**TERRA WIND ENERGY -GOLDEN VALLEY
WIND ENERGY FACILITY, BLUE CRANE
ROUTE LOCAL
MUNICIPALITY, COOKHOUSE - EASTERN
CAPE PROVINCE**

DEA ref: 12/12/20/1717

**MOTIVATION FOR AMENDMENT OF
ENVIRONMENTAL AUTHORISATION**

Figure 1: Bat activity variation at height for January - May 2012, for each passive system.

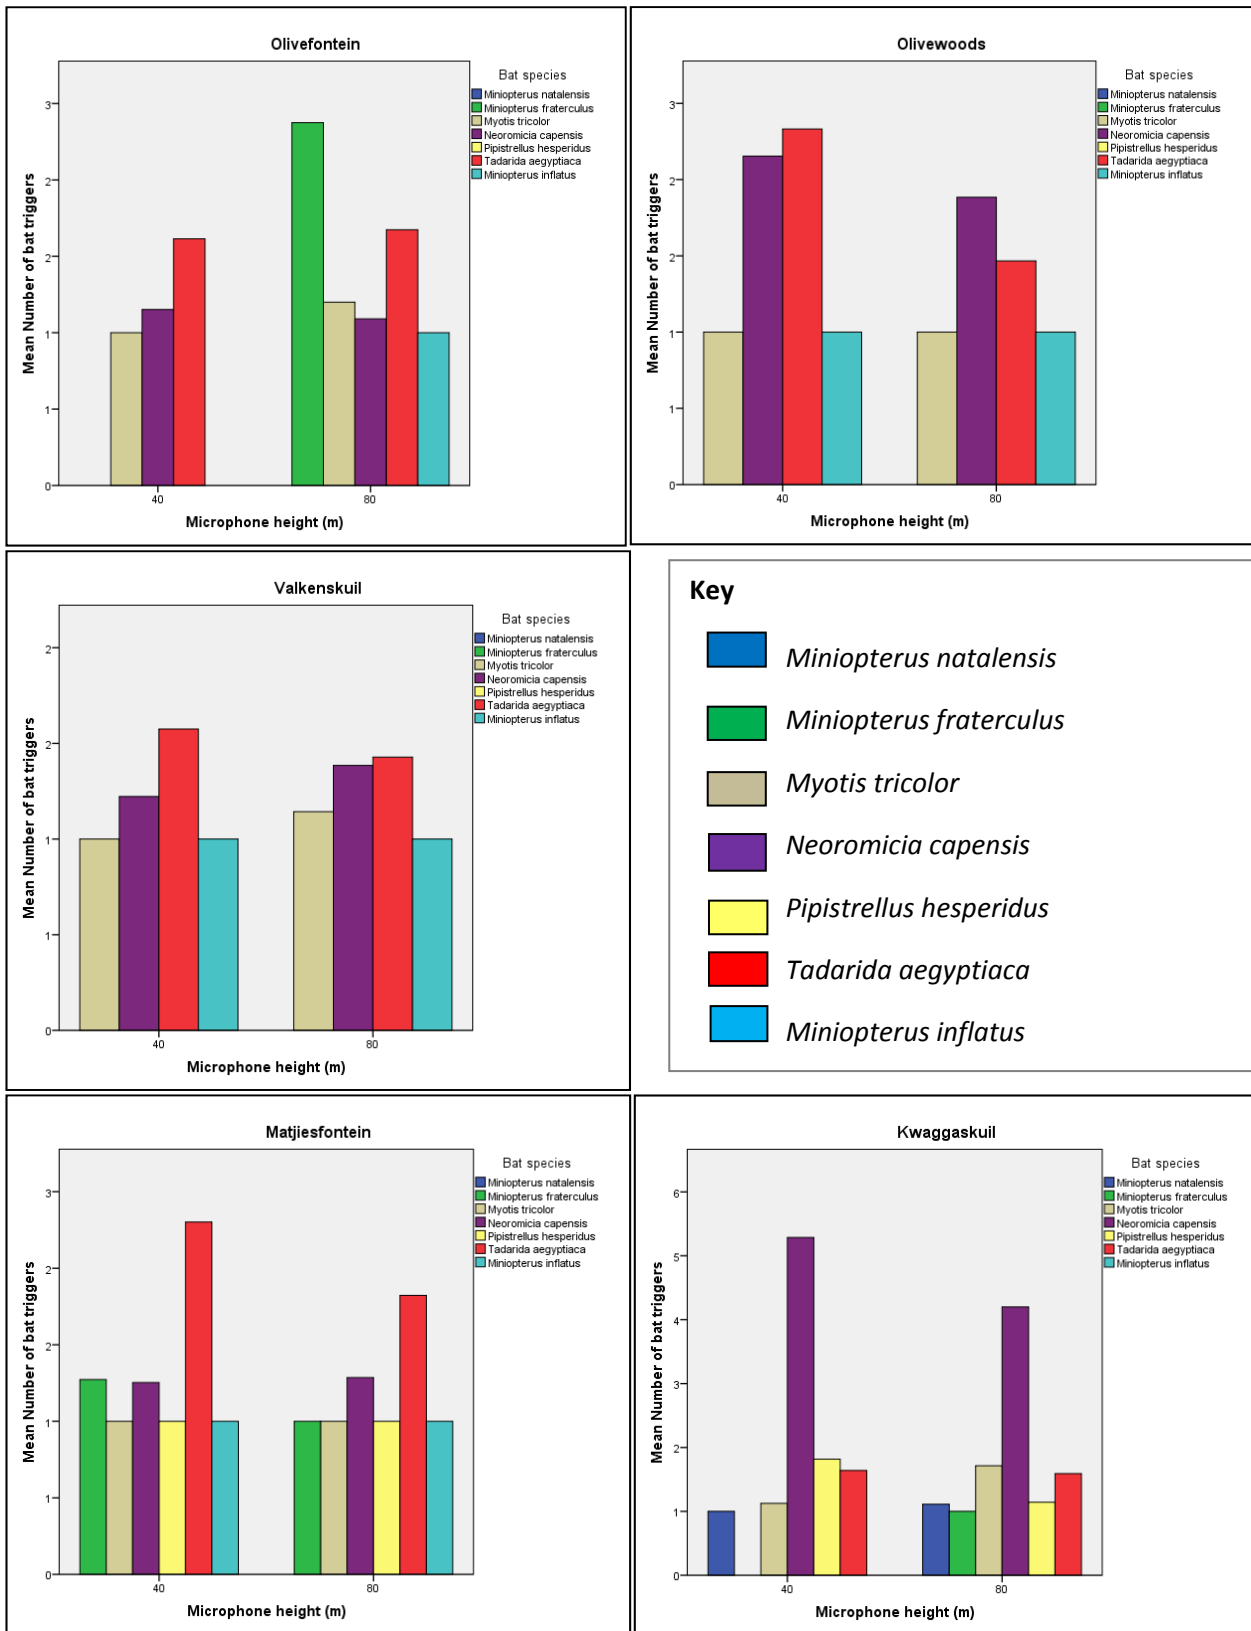
Figure 1 indicates levels of bat activity at the 2 different heights, measured in average bat triggers / bat passes for the period of late January to early May 2012. **Figure 2** indicates levels of bat activity at the 2 different heights, measured in average bat triggers / bat passes for the period of early May to end July 2012. In both figures it can be seen that the majority of bat activity at 80m is less than at 40m in most cases. No migrations have been detected on site so far, therefore the graphs under discussion were analysed from foraging bats. Should a migration be detected, the proposed turbines will need to be mitigated during the time period of the migration.

According to data gathered and analysed up to date during the long term preconstruction bat monitoring, an increase in turbine size and height will not increase the mortality risk to foraging bat fauna. The risk may possibly remain unchanged, but the proposed amendment is not anticipated to increase the risk of mortality to resident foraging bats on site.

Figure 0-1 Farmstead potentially affected by change in turbine height. The building is surrounded by tall trees and clear views of wind turbines will be limited. (Source: Google Earth)

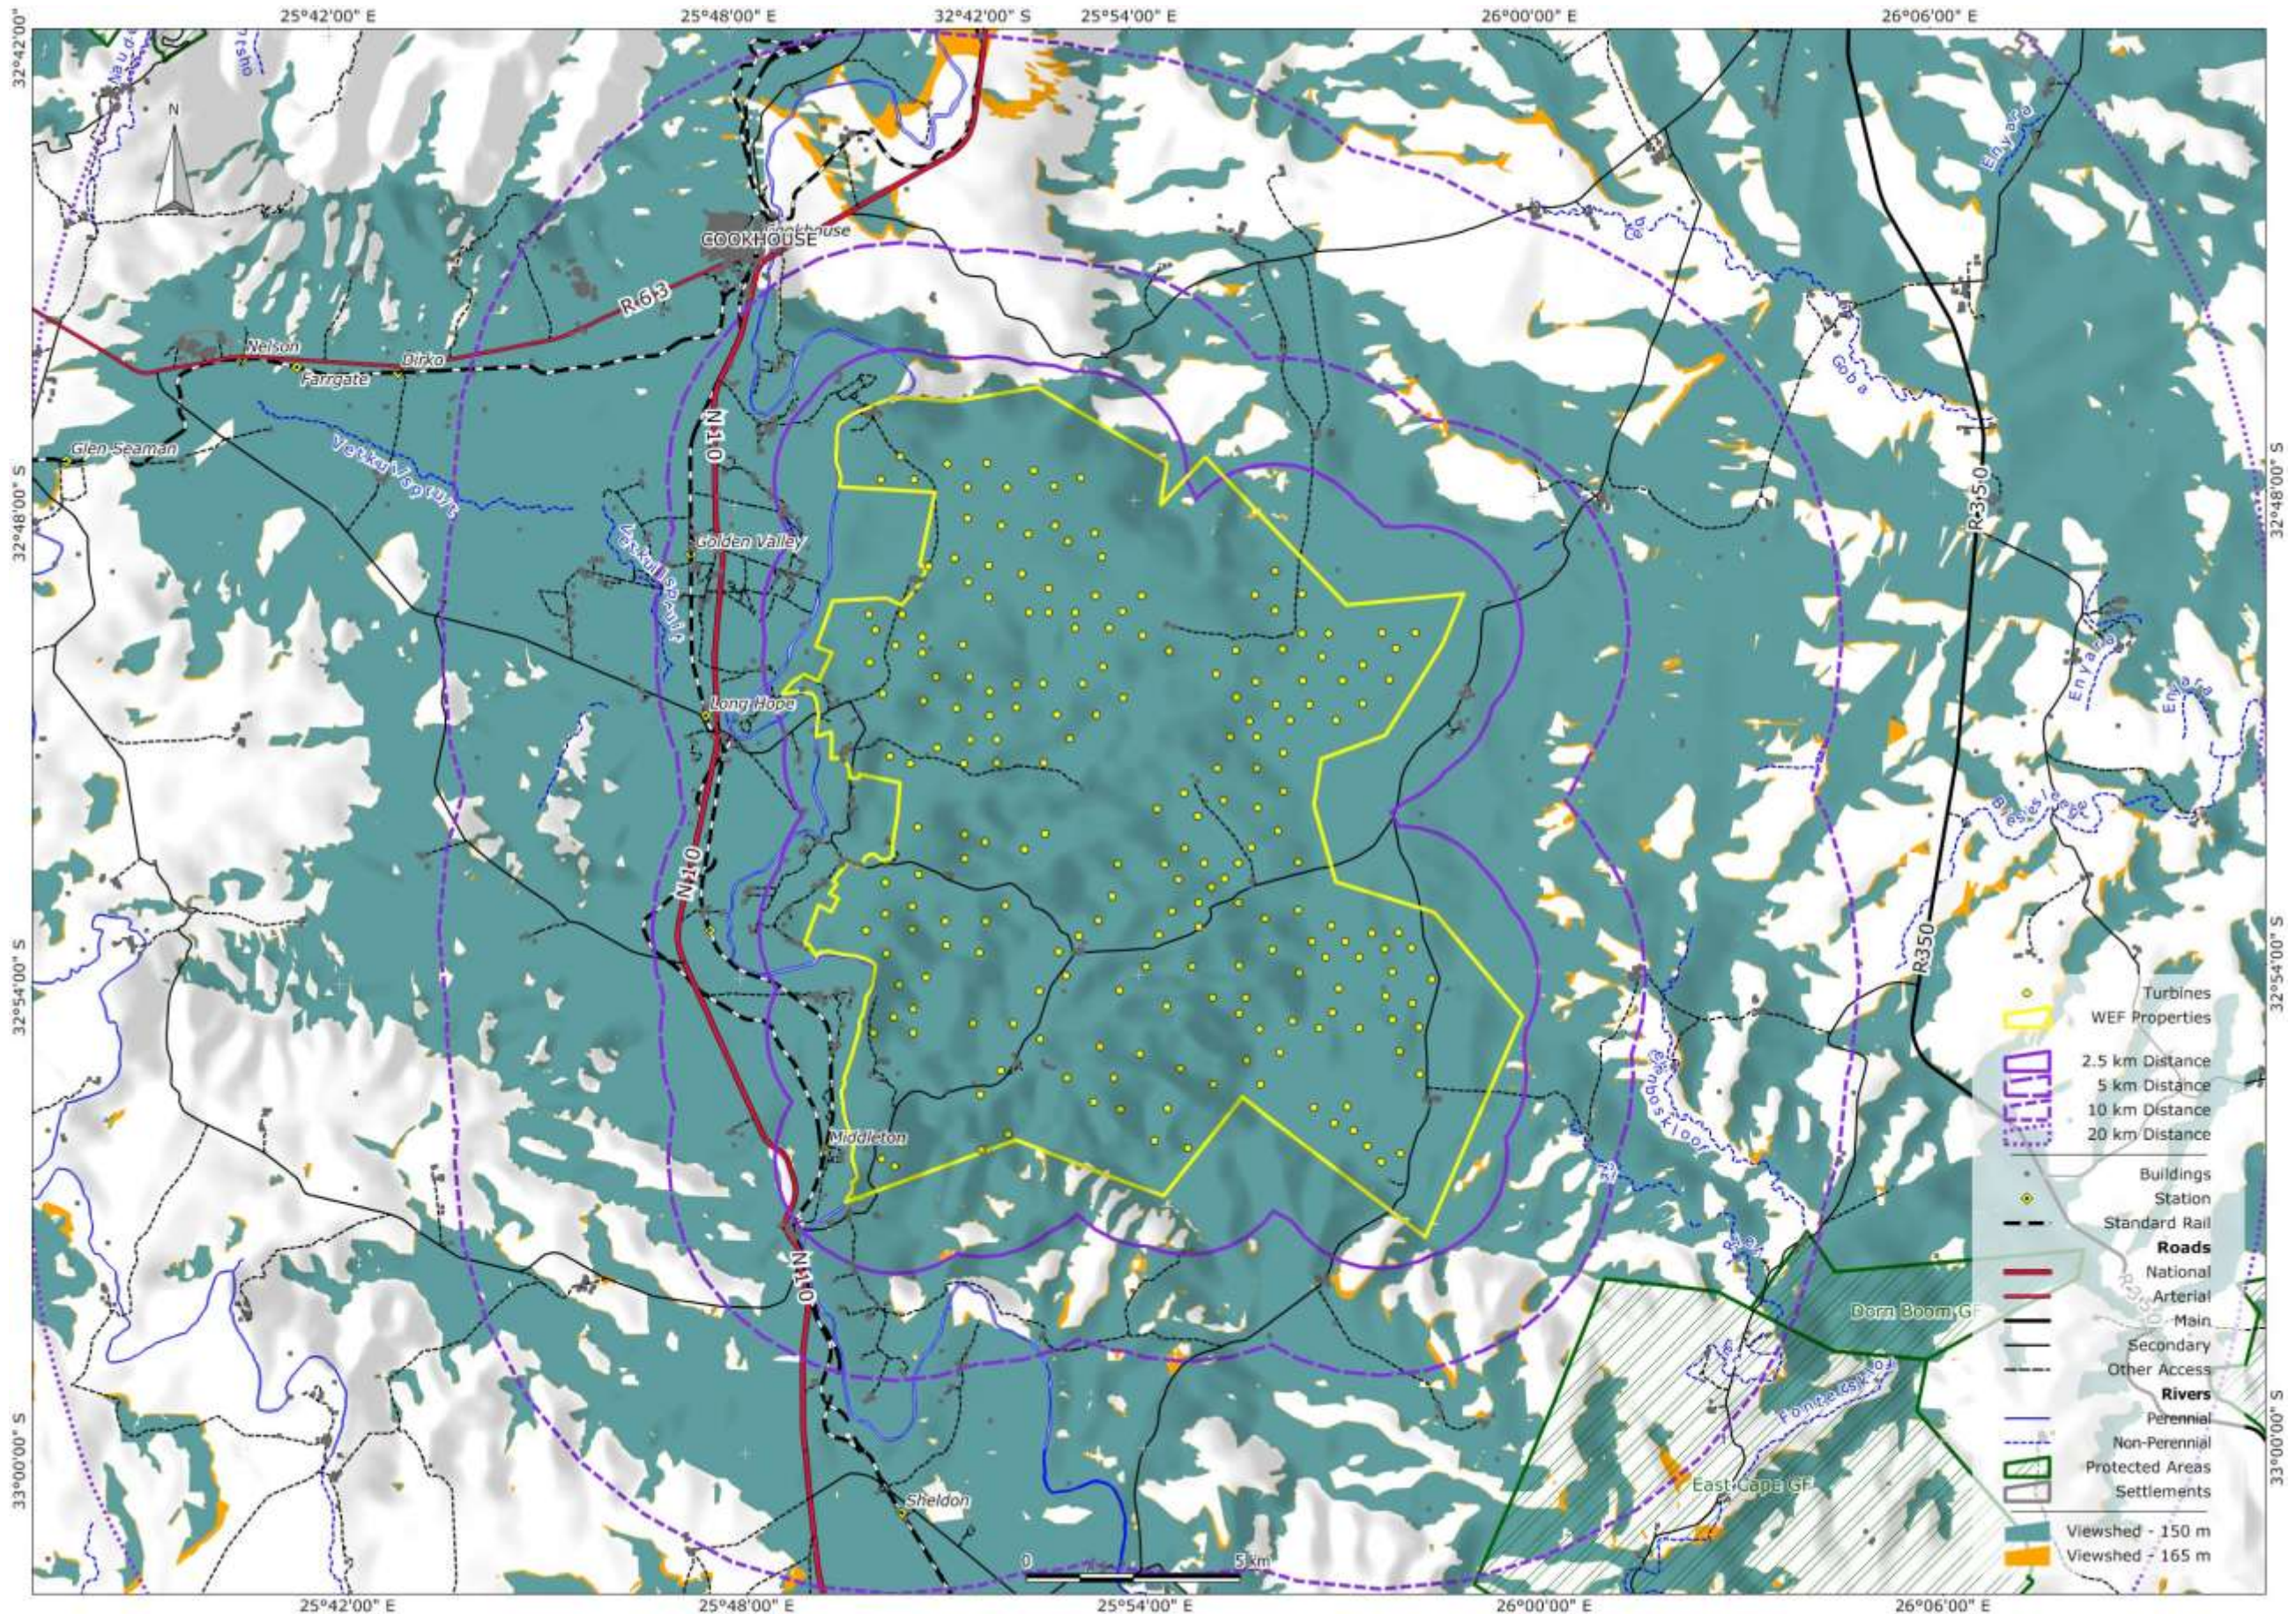
The difference in turbine height increases the viewshed area by 41 km² and the number of buildings that will potentially be affected by 45³ Map 1 provides a visual comparison of the two viewsheds. From this it is clear that the increase in viewshed area occurs mostly beyond 5 km from the nearest wind turbines where visual exposure to the wind farm will tend to be medium to low. Of the 45 buildings potentially affected by the increased turbine height only one is closer than 6 km from the nearest turbine. It is a farmstead surrounded by tall trees and is unlikely to have clear views of turbines (Figure 0-1). The significance of the visual impact on sensitive visual receptors was rated as high in the original VIA report and an increase of 15 m in turbine height will not change this rating.

Map 1 Comparison of viewsheds for 150 m and 165 m wind turbines. The viewshed for the most recent layout(orange) is slightly larger than that of the layout used for the visual impact assessment (15 May 2011 – green).
